HUNTS POINT INTERSTATE ACCESS IMPROVEMENT PROJECT – CONTRACT 3

PIN X731.65, Contract D900055

Addendum #8

July 22, 2022

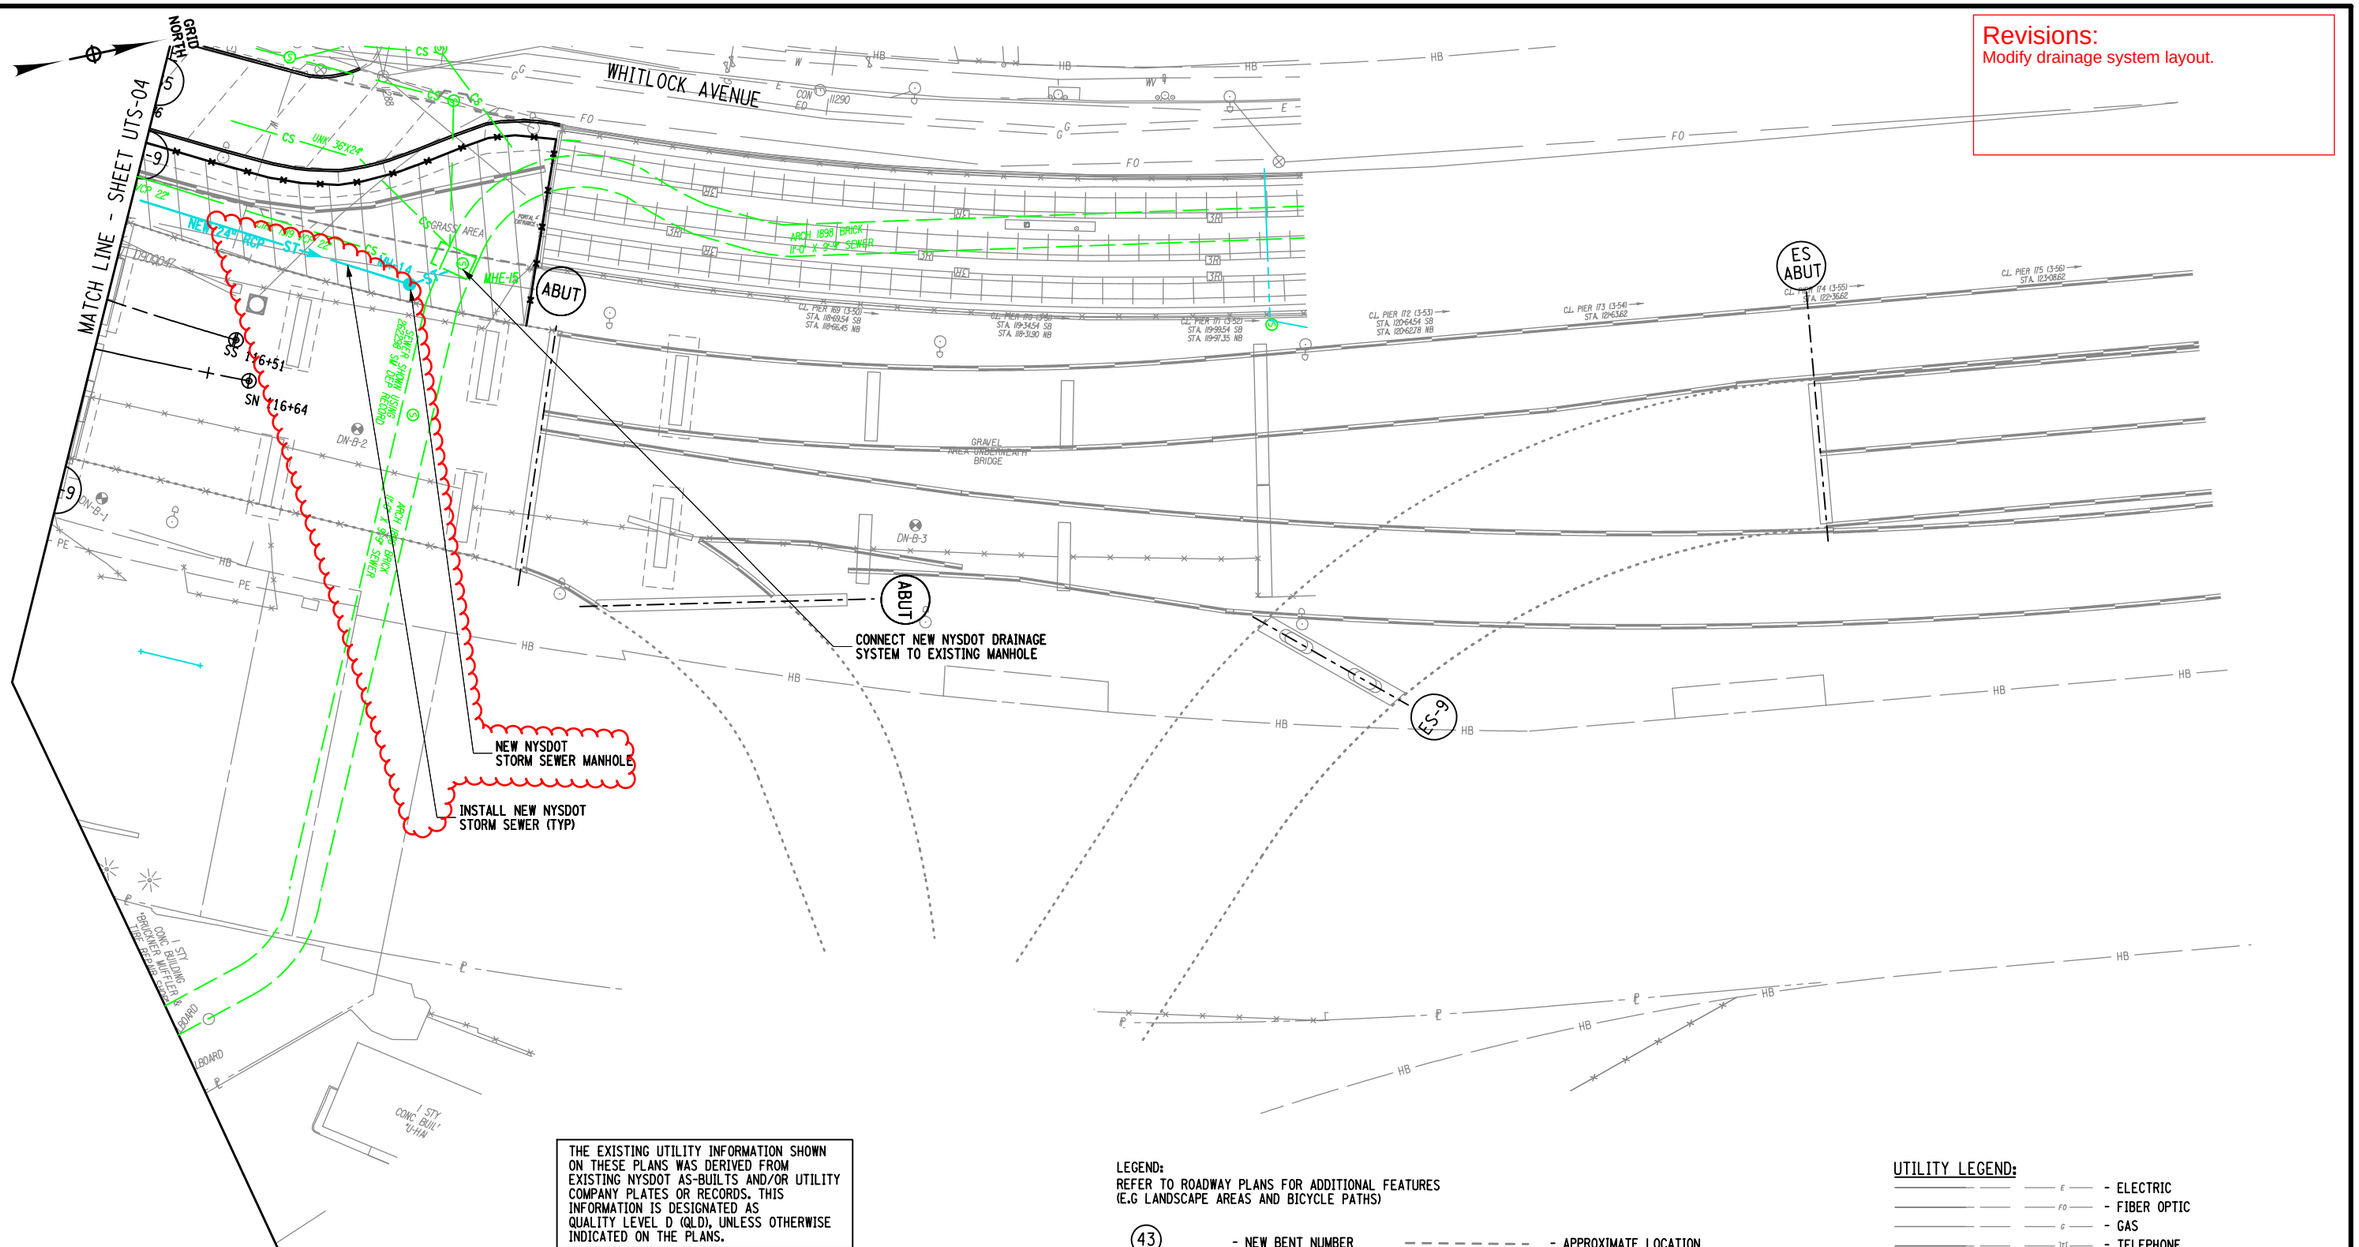
Revisions:
Modify drainage system layout.

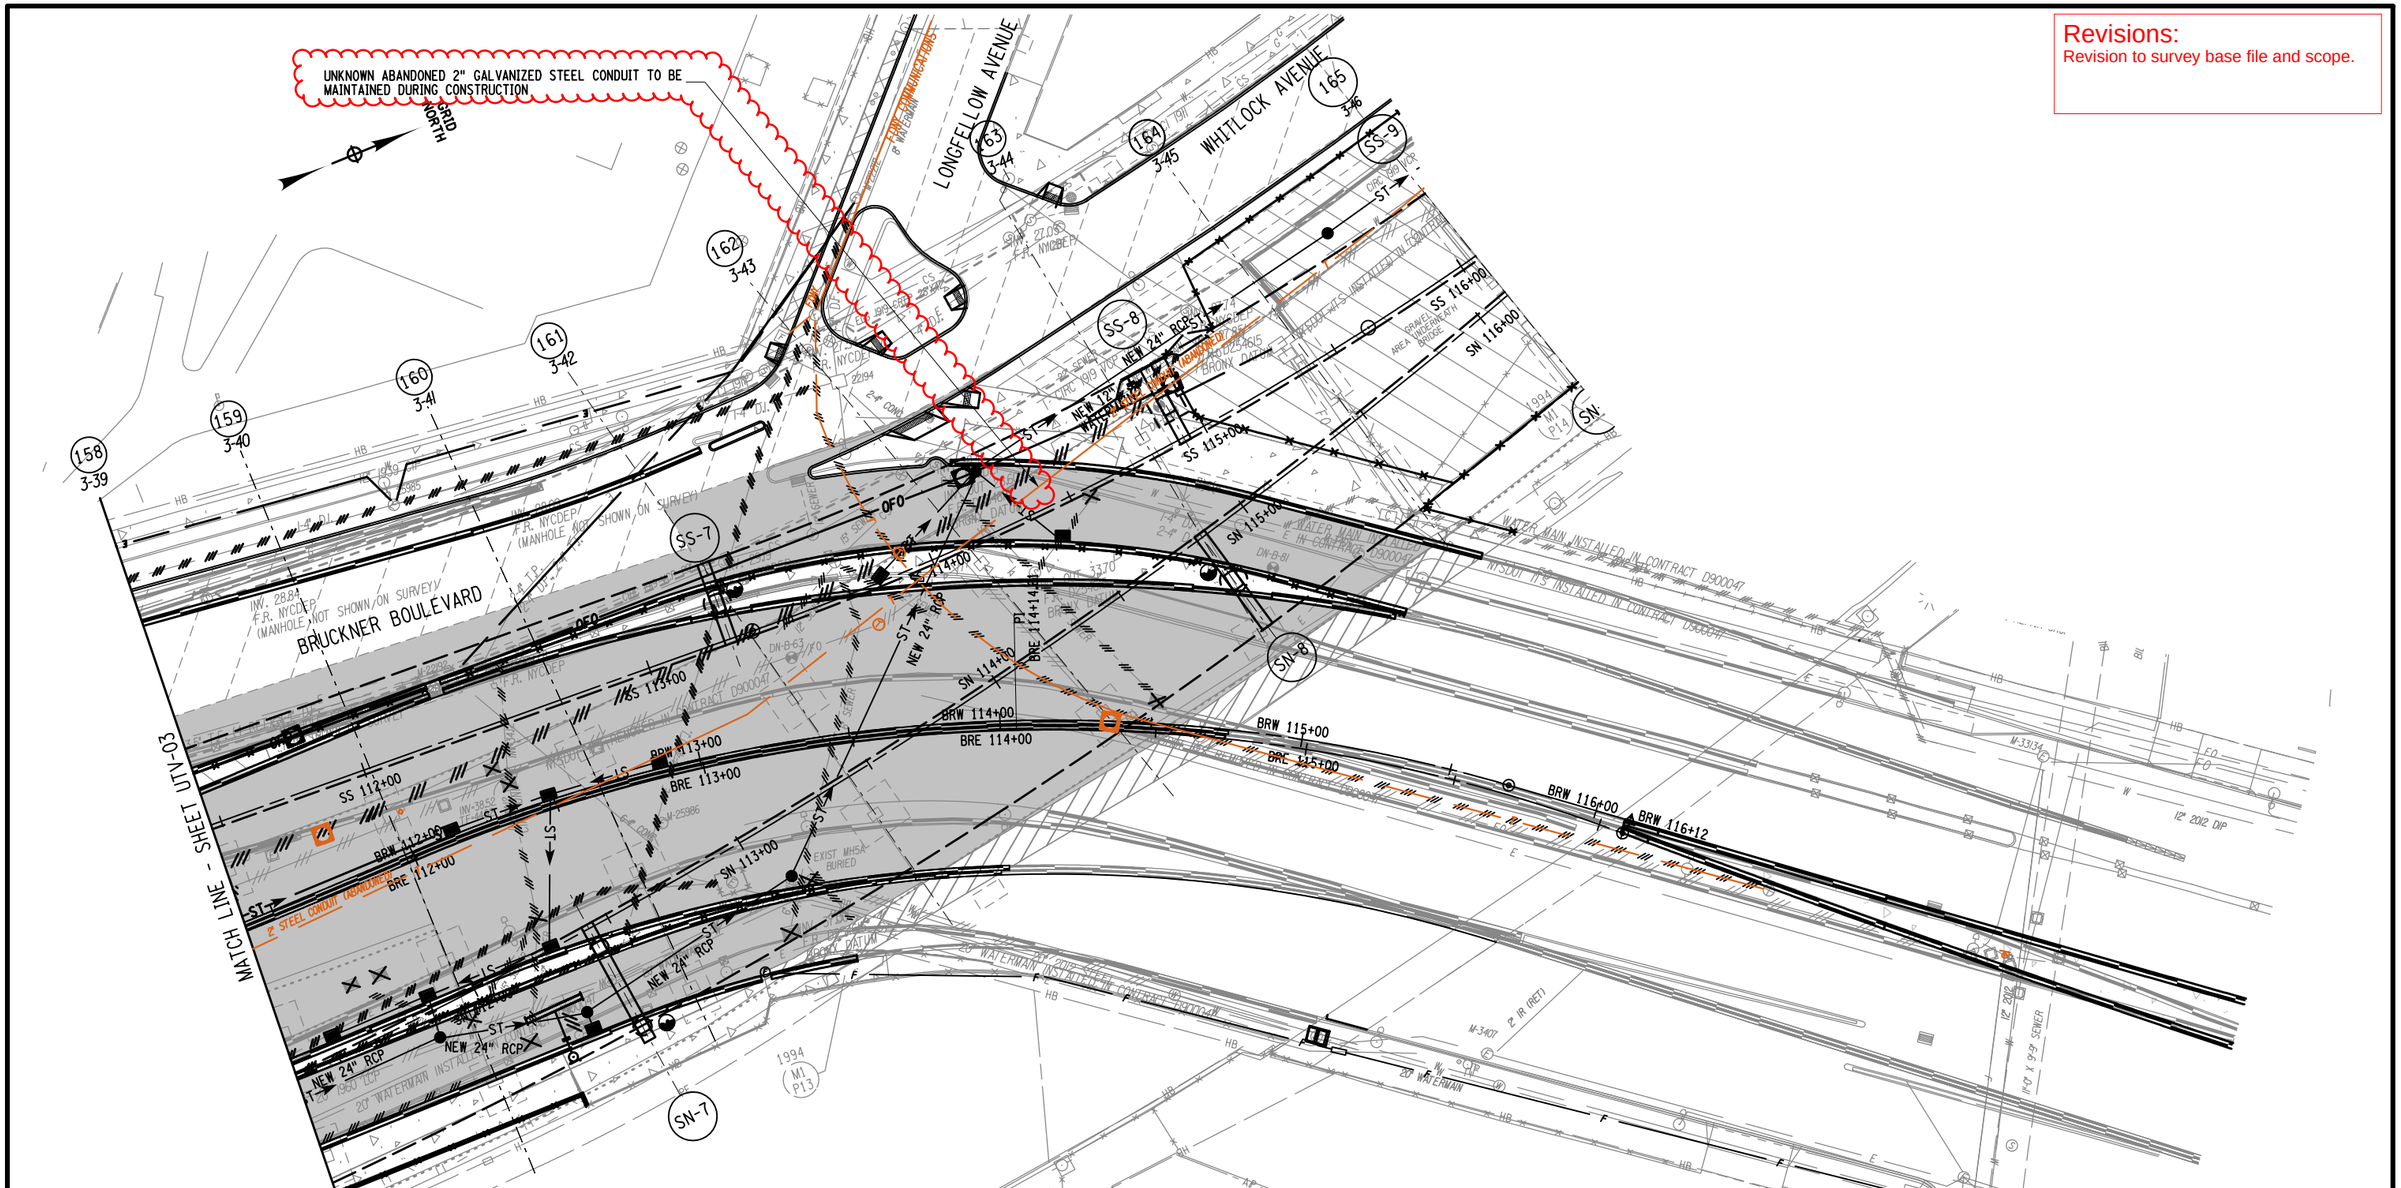
Revisions:
Revision to survey base file and scope.

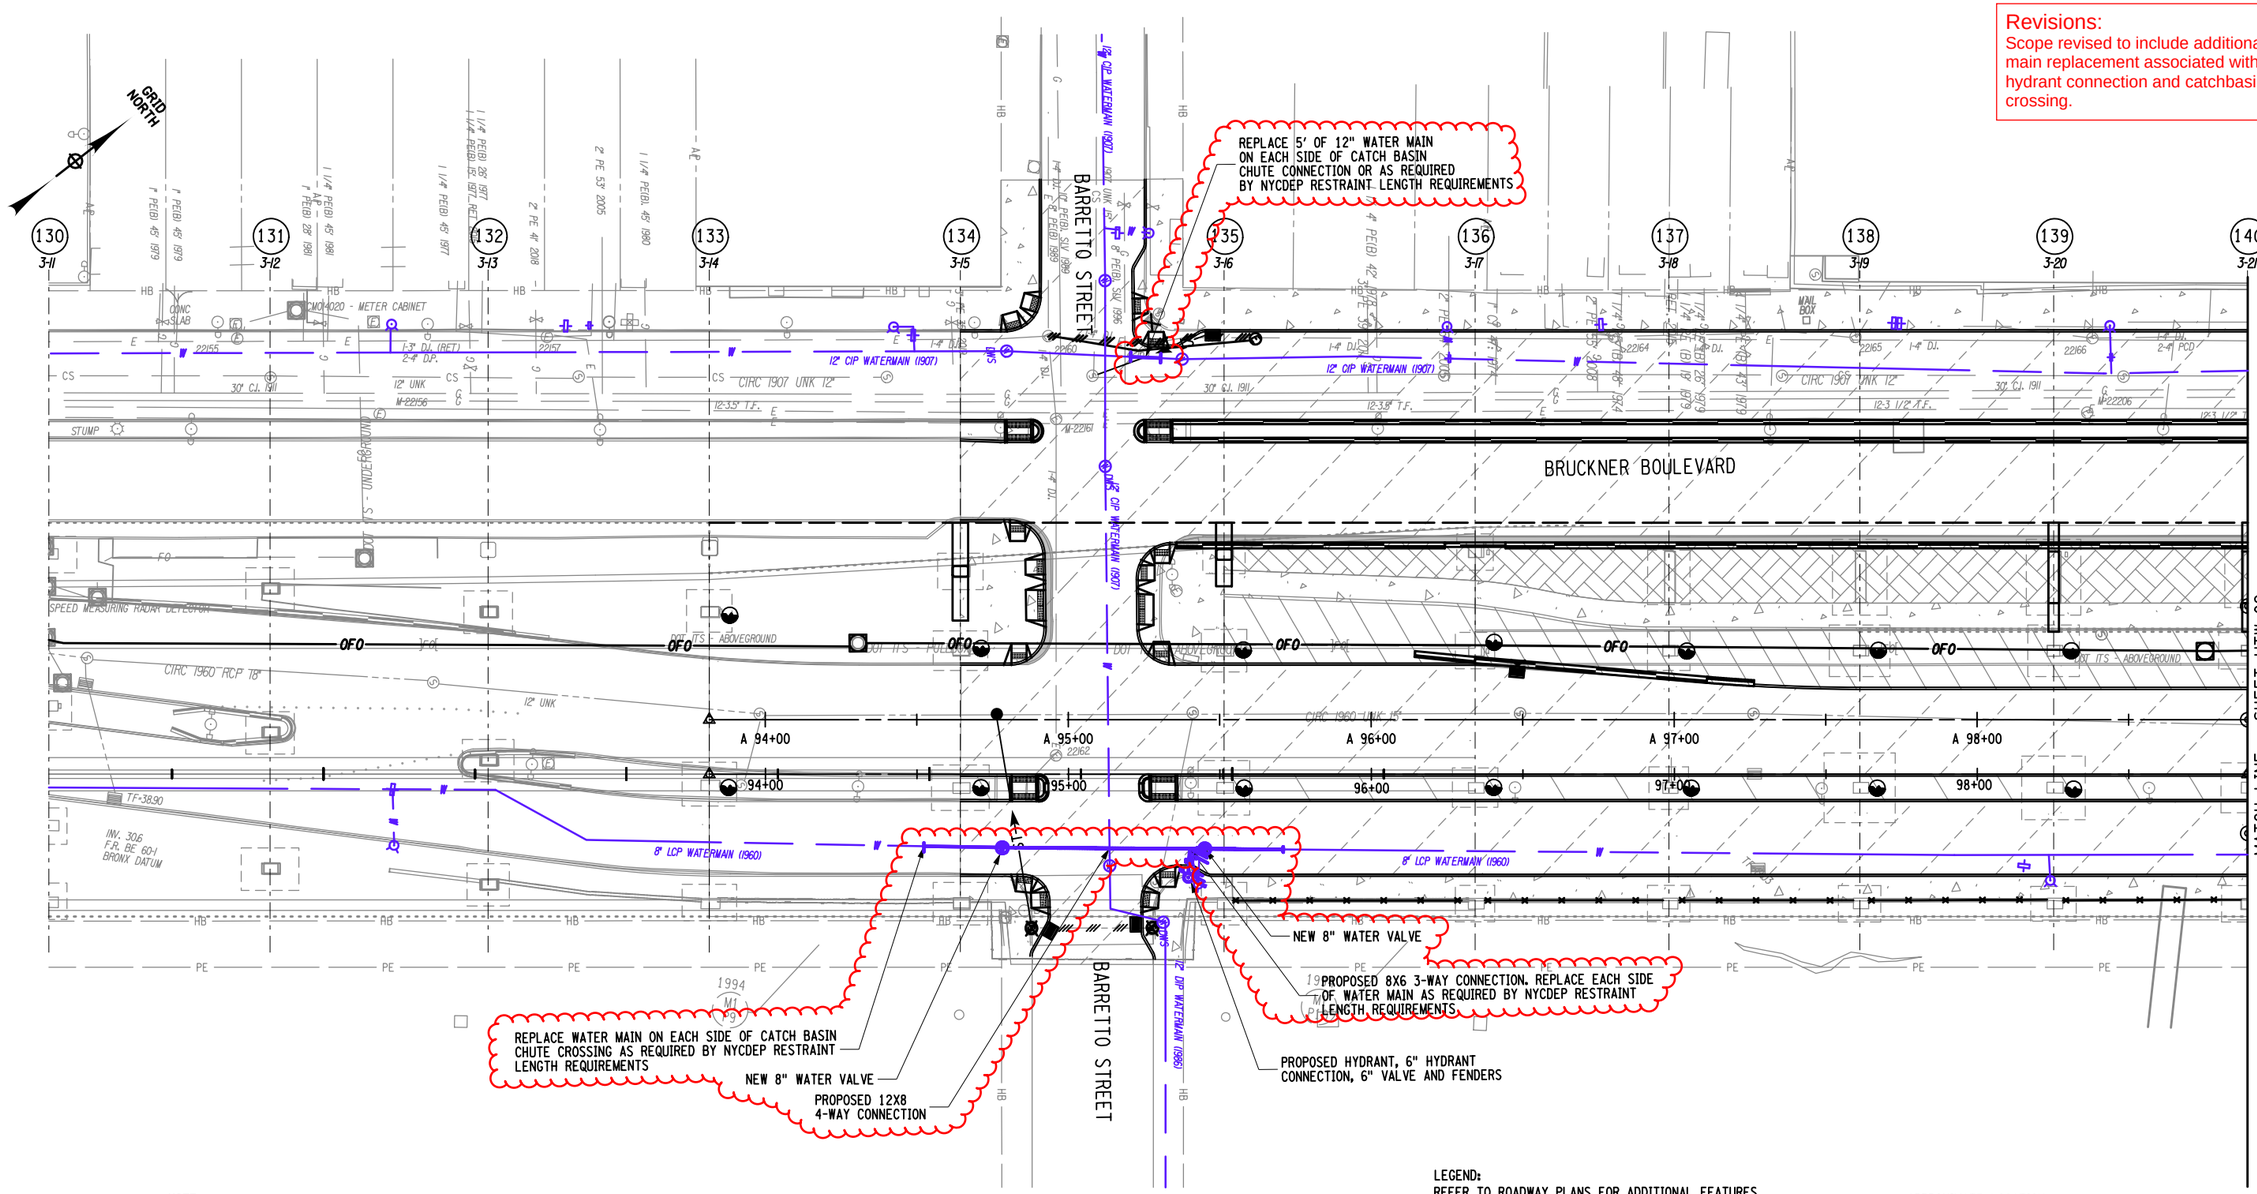
Revisions:
Scope revised to include additional water main replacement associated with hydrant connection and catchbasin chute crossing.

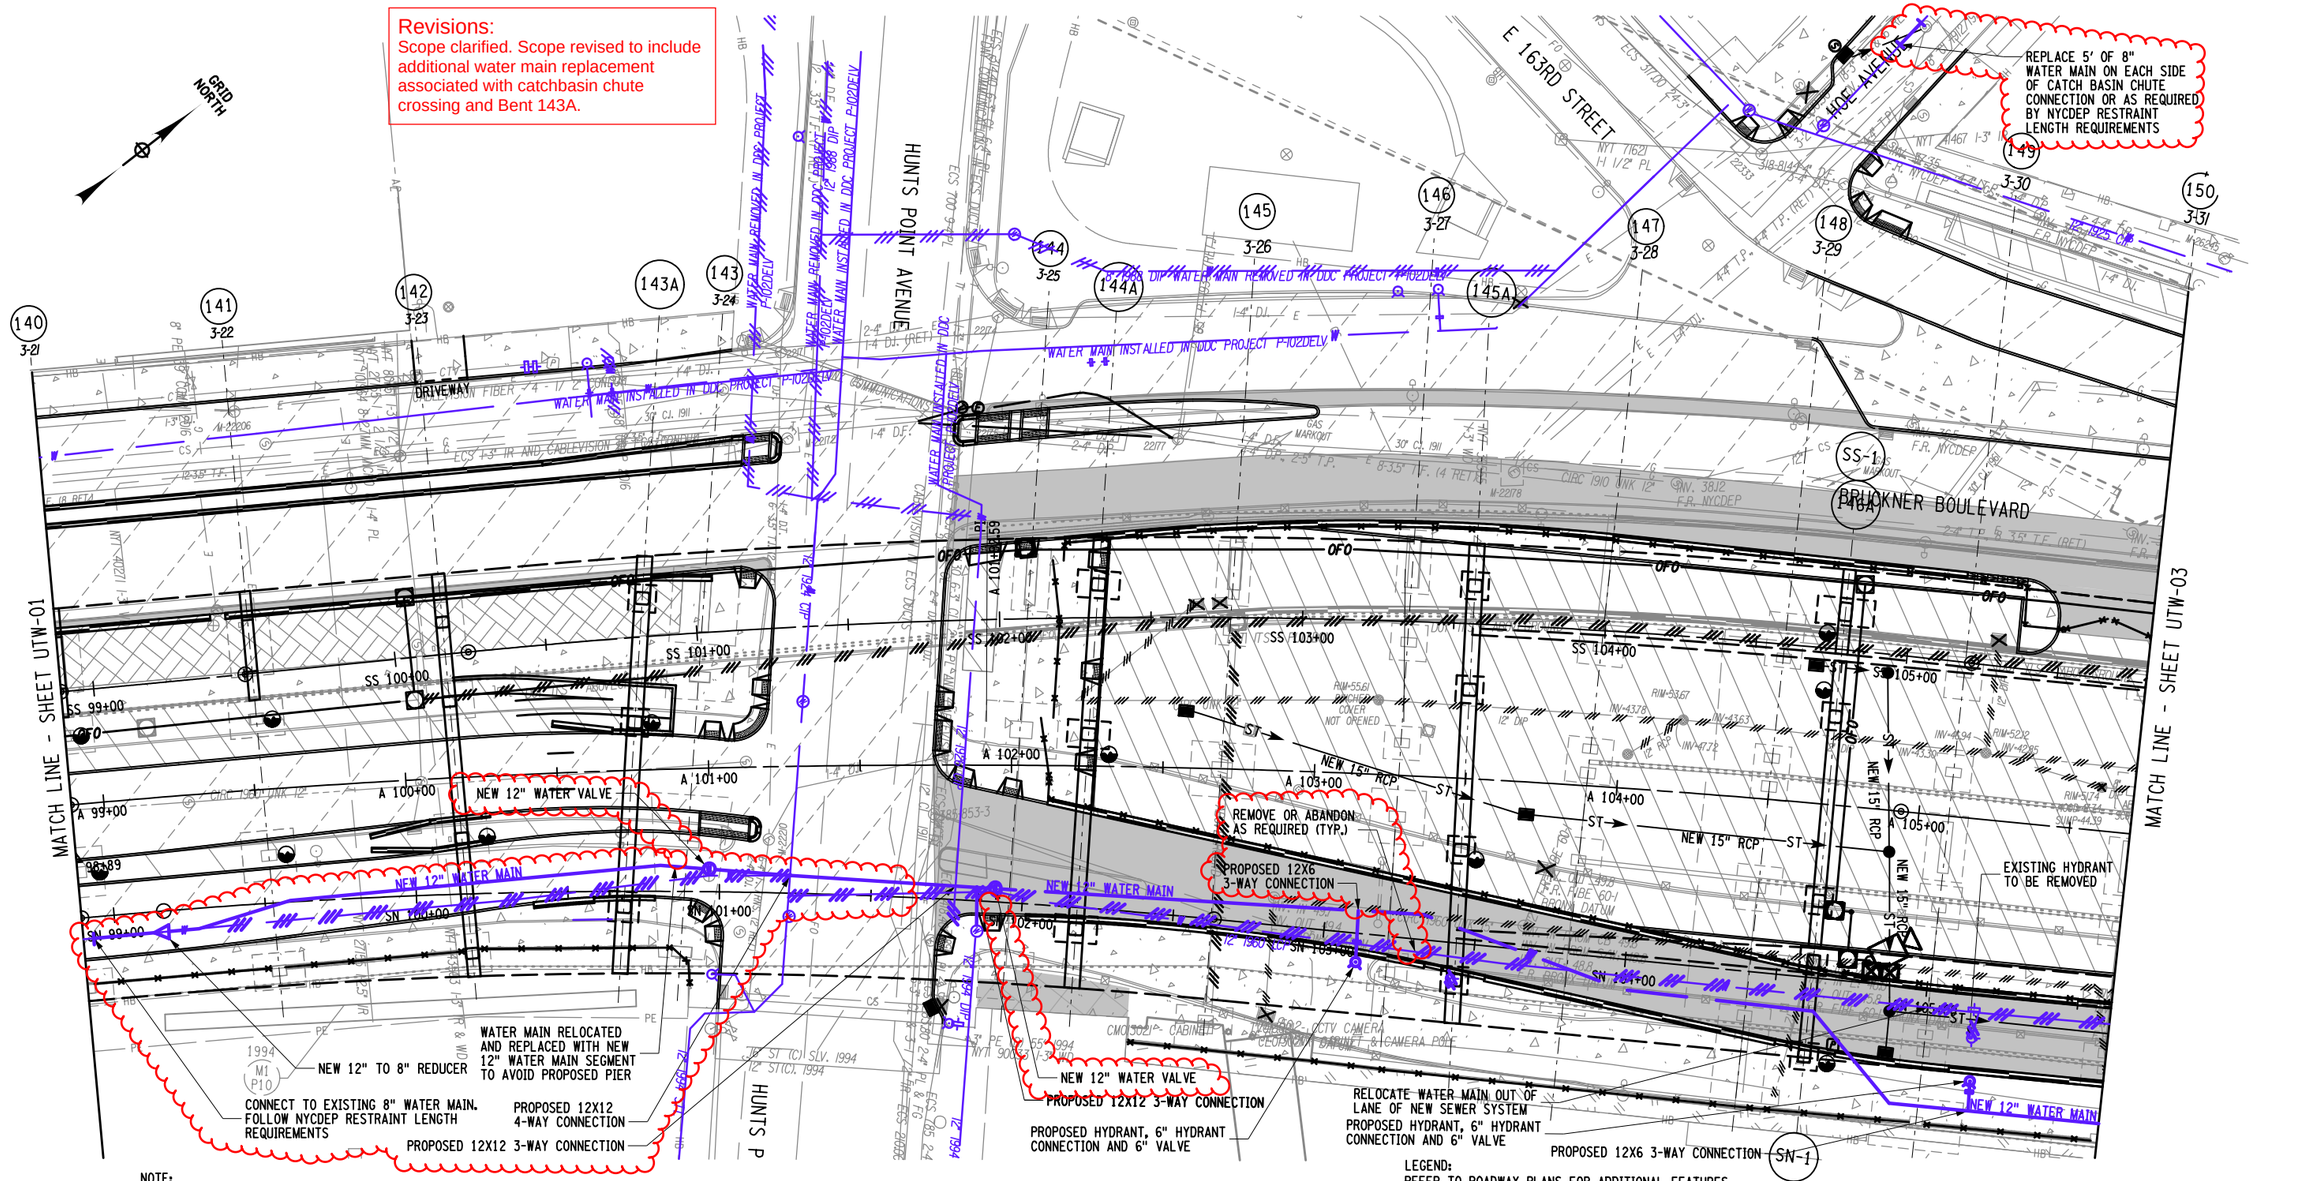
Revisions:
Scope clarified. Scope revised to include additional water main replacement associated with catchbasin chute crossing and Bent 143A.
